ENGINEER'S
SUPPLEMENTAL INSTRUCTIONS

PROJECT:200 E 6th ST WallENGINEER'S SUPPLEMENTAL

(name, address)Austin, Texas 78701INSTRUCTION NO: 2

Demolish west exterior masonry wall at third and rebuild with CMU wall and reclaimed brick veneer.

ATTACHMENTS: Sketches

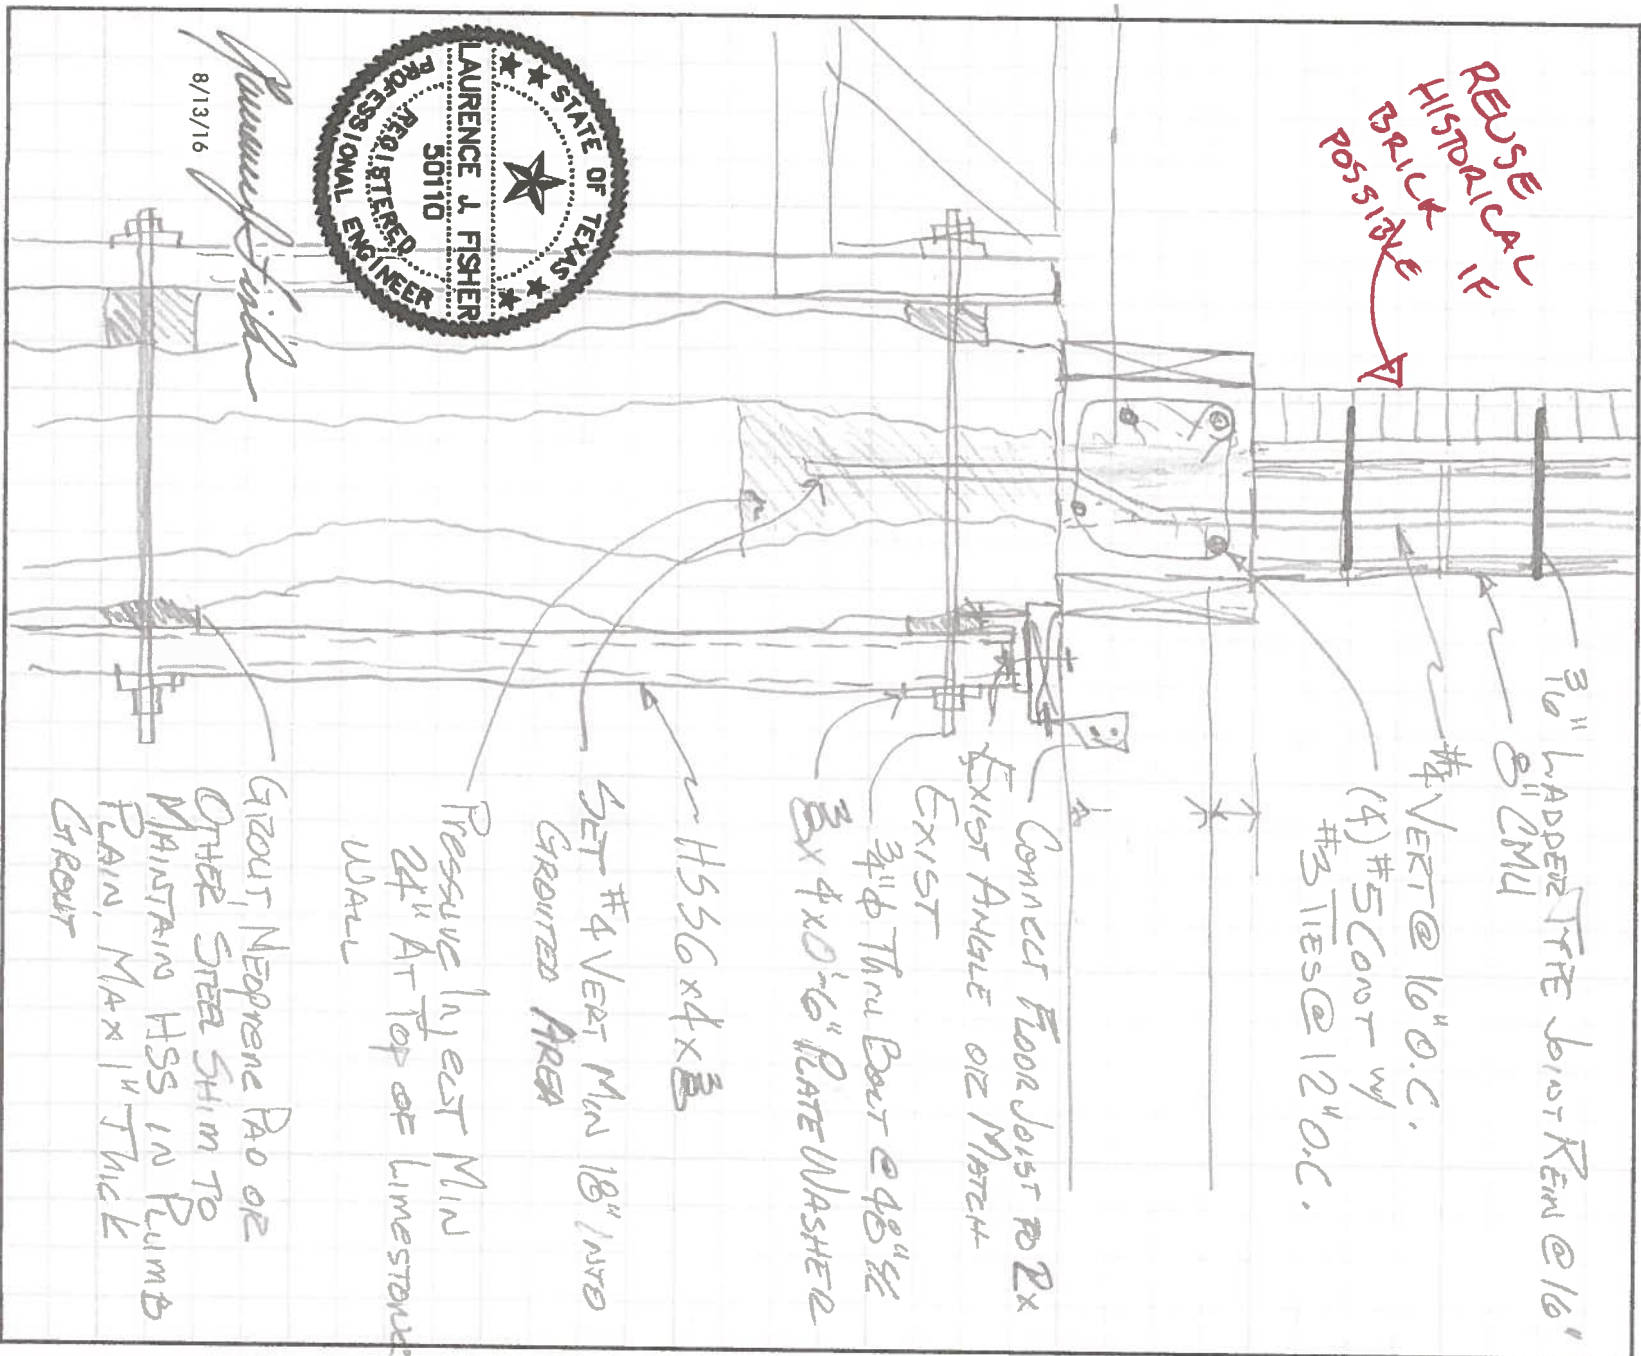
- 1) Shore third floor joists
- 2) Reinforce lower section wall between second floor level and third floor level
- 3) Reattach third floor joists to wall reinforcing
- 4) Shore roof trusses
- 5) Demo existing masonry wall in sections
- 6) Install rebar dowels at top of existing masonry wall
- 7) Pressure inject upper 24" of existing masonry wall
- 8) Construct minimum 12: deep tie beam at top of existing masonry wall, leaving sufficient reinforcing exposed to provide 40 diameter lap to next section of wall.
- 9) Construct 8" CMU wall for section
- 10) Attach roof trusses to new wall
- 11) Weatherproof section of wall
- 12) Repeat for each section of wall
- 13) Waterproof and insulate CMU wall
- 14) Install windows
- 15) Construct brick veneer
